Determination 2021/020

Regarding the refusal to issue a code compliance certificate for 23-year old additions and alterations to a residential dwelling at 36 Knights Road, Rothesay Bay, Auckland

Figure 1: First floor plan [not to scale]

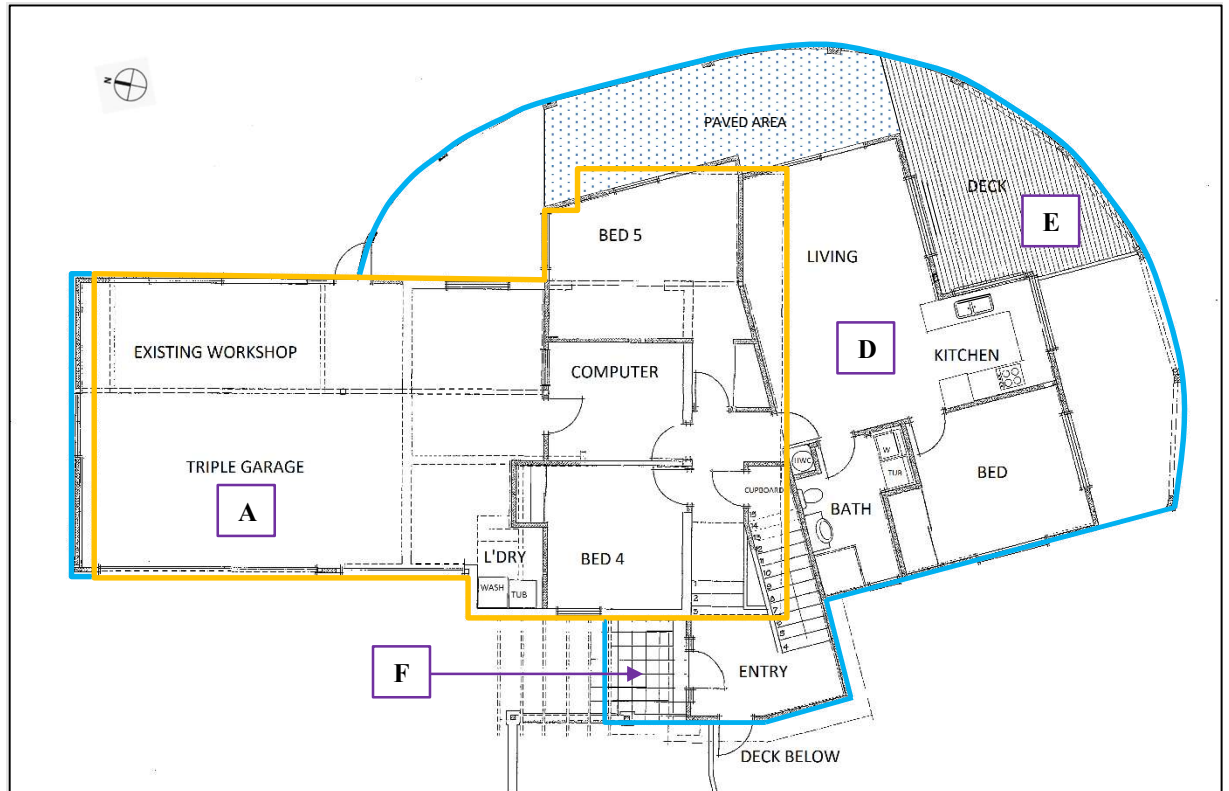
2.6 The entrance canopy roof (item “F”, figure 2) comprises direct fixed tiles over a liquid applied membrane, which is specified in the 1998 building consent as a 1.5mm butyl rubber membrane. The membrane is installed over a fixed plywood substrate and supporting timber framing.

Photo 2: Ground floor, northwest corner – stone schist cladding

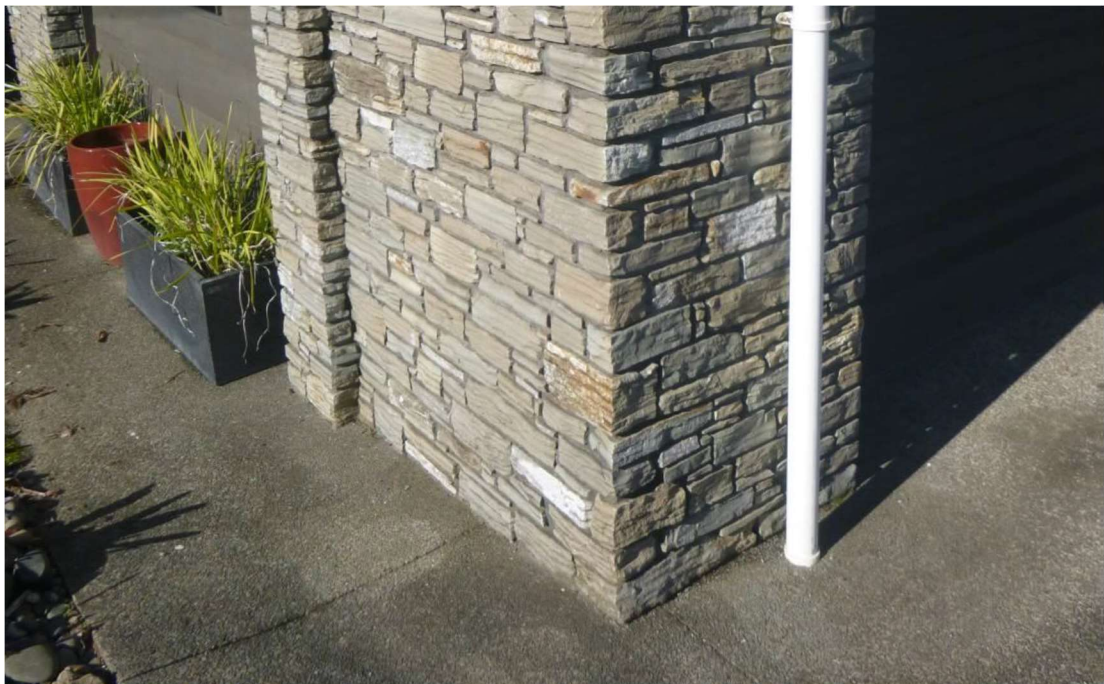
- 5.12 The expert noted the stone schist cladding was built up like a brick veneer cladding over a cavity with weep holes at the base and that it was, in parts, at or below driveway level as indicated in the photographs included in the expert's report. The expert also noted it was not clear whether a damp proof course had been installed and whether the foundation was stepped.
- 5.13 The expert also stated "the schist veneer stonework was found to be performing. Although some insufficient ground clearance exists near the garage door, and the driveway slopes toward the corner of the building" (see photo 2).
